APPLICATION NO.	FILING DATE	FIRST NAMED INVENTOR	ATTORNEY DOCKET NO.	CONFIRMATION NO.
10/624,413	07/22/2003	Robert T. Long SR.	1547520/72600	7602

Office Action Summary

This is a second office action for serial number 10/624413, entitled Concrete sandwich wall panels and a connector system for use therein, filed on July 22, 2003.

FIG. 2

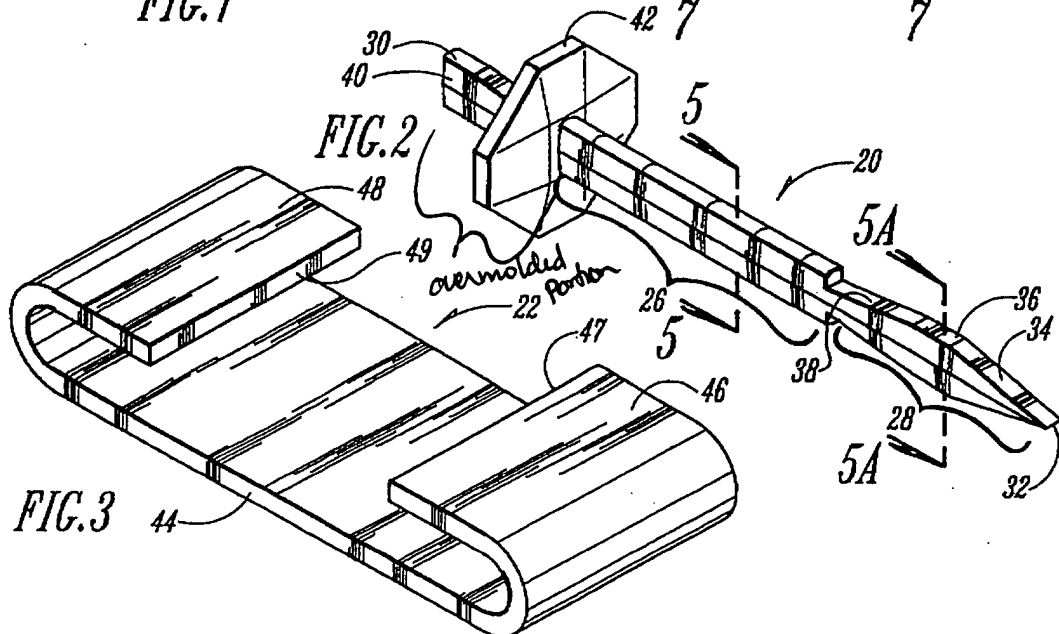
Long discloses the claimed invention a connector element (20) comprising a fiber composite shaft (26 – column 4, lines 27-28) with at least one over-molded component (interpreted as in attached figure 2) comprising anchorage ends (30 and 40 – figures 2 and 9) and one or more locating flanges (42); anchorage ends (30,40) provide bi-directional force transfer between (by column 1, lines 56-61) the connector body (at 20) and surrounding concrete (12 and 14); snap features (near edge of 30 and 28 in figures 9); and a pointed end (32).

Regarding the applicants argument that the Long reference does not describe a connector with one or more over-molded components, the examiner recognizes the argument, however, the examiner has incorporated an attached figure as stated within the rejection above to address the added limitation an over-molded component, also, since the applicant was not clear within the disclosure or within the drawings as to what exactly this limitations is referring to or is in particular to the structure itself, the examiner has made the interpretation of this limitation as best understood. Also, it is noted that the features upon which applicant relies (i.e., one or more over-molded component) are not recited in the rejected claim(s). The claim states at least one over-molded component comprising anchorage ends and *one or more locating flanges*. Although the claims are interpreted in light of the specification, limitations from the specification are not read into the claims. See *In re Van Geuns*, 988 F.2d 1181, 26 USPQ2d 1057 (Fed. Cir. 1993).
